Proposed Revisions to a Standard Plans Index

Index Number: 700-120

Sheet Number (s): 1 of 11

Index Title: Enhanced Highway Signing Assemblies

INDEX
700-120

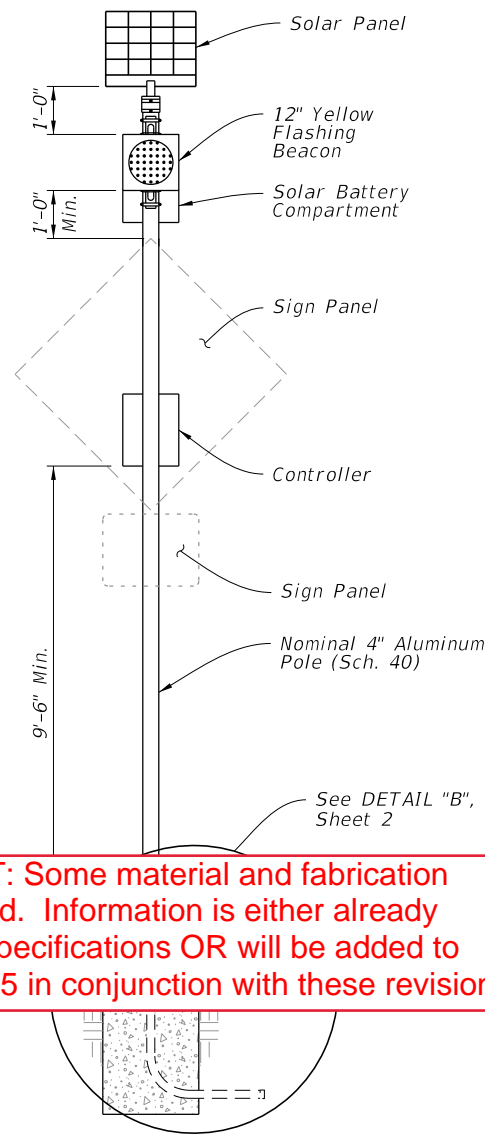
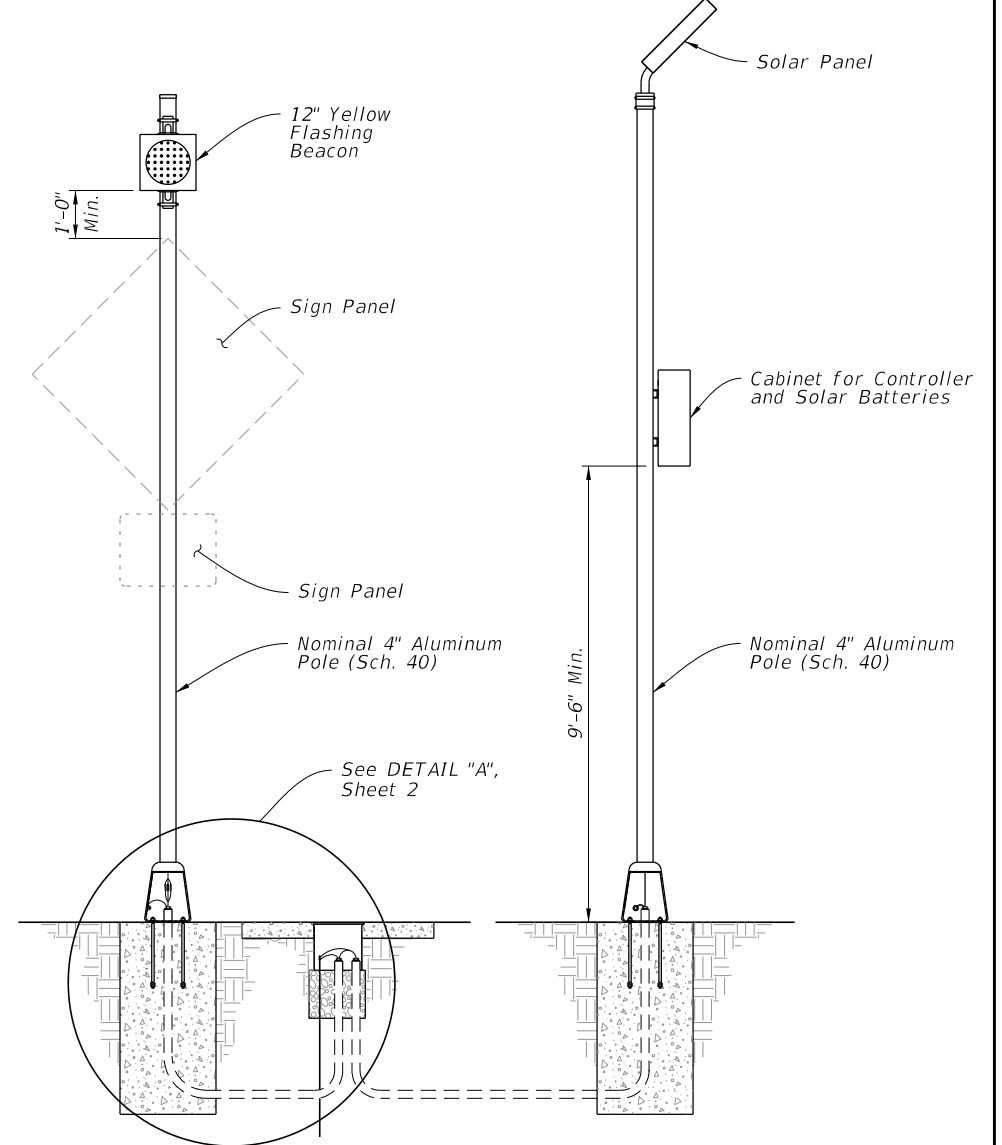
GENERAL COMMENT: Some material and fabrication information was deleted. Information is either already covered in Standard Specifications OR will be added to Section 700, 962 or 965 in conjunction with these revisions.

- ~~1. Install sign assemblies based on Alpha-Numeric Type designation shown in the Plans (e.g., Type A1). Assembly Type is based on Power Configuration 'Alpha' identification shown above and Numerical Identification shown on Sheet 3 thru 8.~~
- ~~2. Install sign panel and wind beam in accordance with Index 700-010 and Specification 700.~~
- ~~3. Engage all threads on the transformer base and post unless the aluminum post is fully seated into base.~~
- ~~4. Meet the requirements of Specification 646.~~
- ~~5. Install a concrete slab around all roadside assemblies on slopes 6:1 or greater. The minimum slab dimension is 6" by 4'-0" by 5'-0".~~
- ~~6. When wire entry holes are drilled in the sign column, use a bushing or rubber grommet to protect conductors.~~

- 1. Install a separate pole for mounting the solar panel, controller and batteries for all roadside assemblies with solar panels, controllers and batteries weighing more than 170 lbs.
- 2. Install the auxiliary pole as close to the right of way boundary as possible.
- 3. ~~so that the height is the same as the assembly.~~
- 4. Orient solar panel to face South for optimal exposure to sunlight.
- 5. The controller and the solar batteries may be located in the same compartment.

INDEX
 700-120

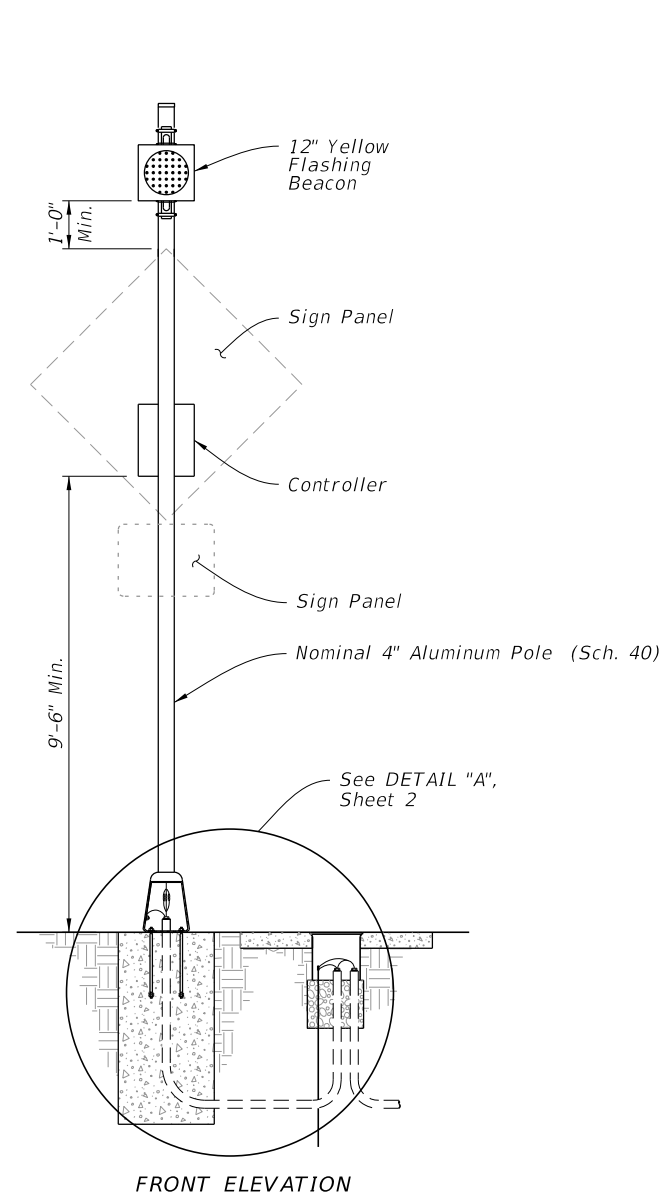
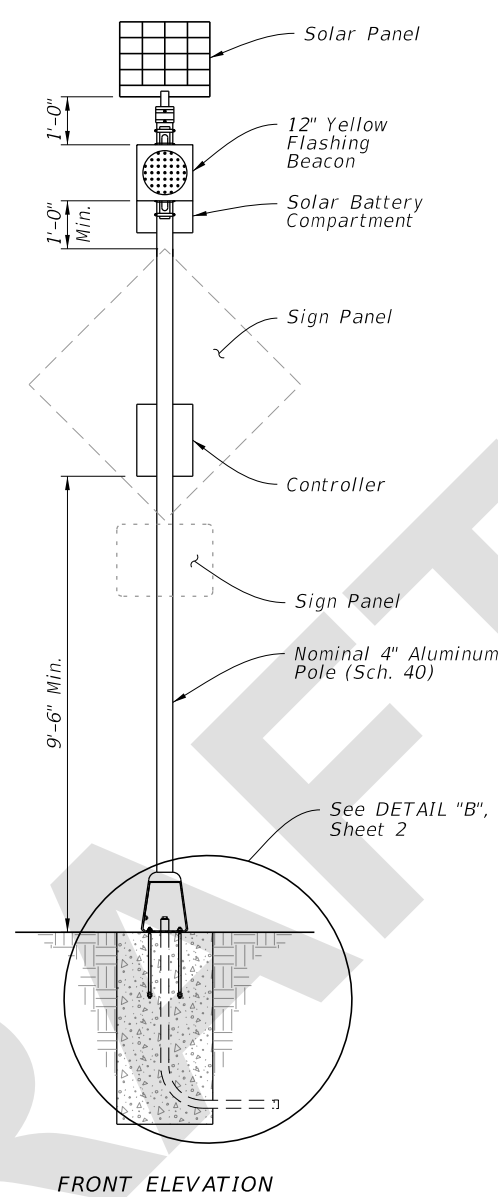
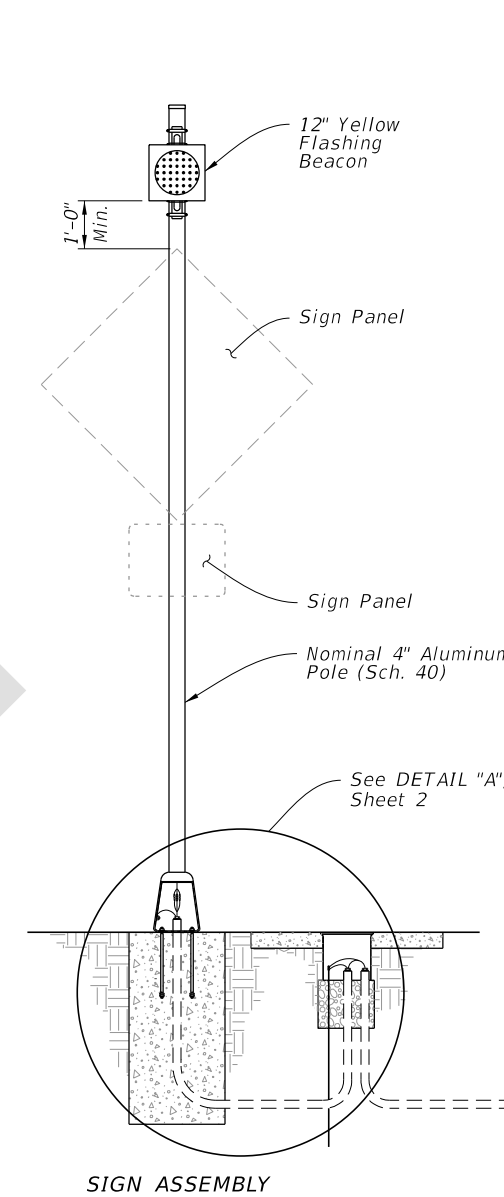
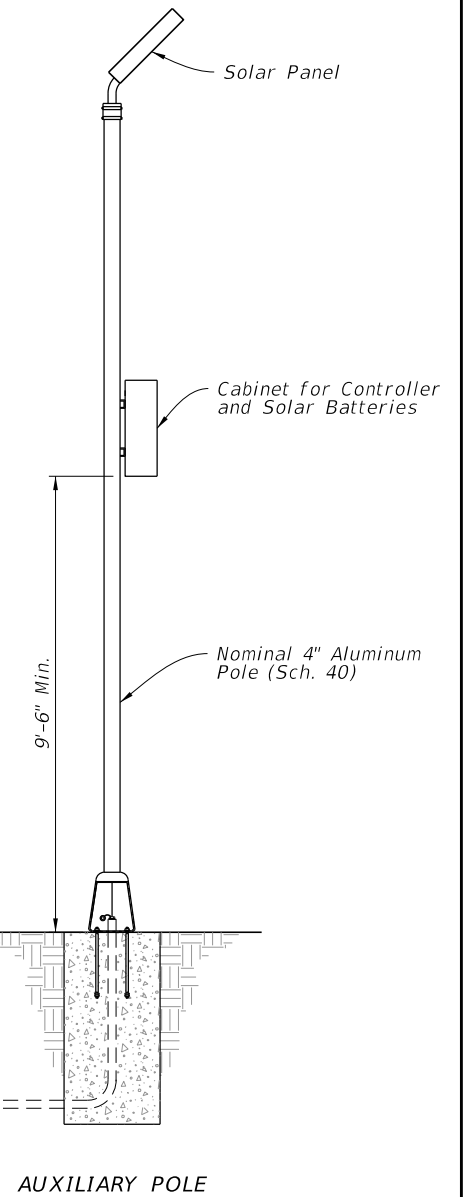
New General Note 1 - "Meet the requirements of Specifications 646 and 700."; Deleted Notes 1, 2, and 4; renumbered General Notes.

1. Meet the requirements of Specifications 646 and 700.
2. Engage all threads on the transformer base and post unless the aluminum post is fully seated into base.
3. Install a concrete slab around all roadside assemblies on slopes 6:1 or greater. The minimum slab dimension is 6" by 4'-0" by 5'-0".
4. When wire entry holes are drilled in the sign column, use a bushing or rubber grommet to protect conductors.

1. Install a separate pole for mounting the solar panel, controller and batteries for all roadside assemblies with solar panels, controllers and batteries weighing more than 170 lbs.
2. Install the auxiliary pole as close to the right of way boundary as possible.
3. Install the auxiliary pole so that the height is the same as the column for the roadside assembly.
4. Orient solar panel to face South for optimal exposure to sunlight.
5. The controller and the solar batteries may be located in the same compartment.
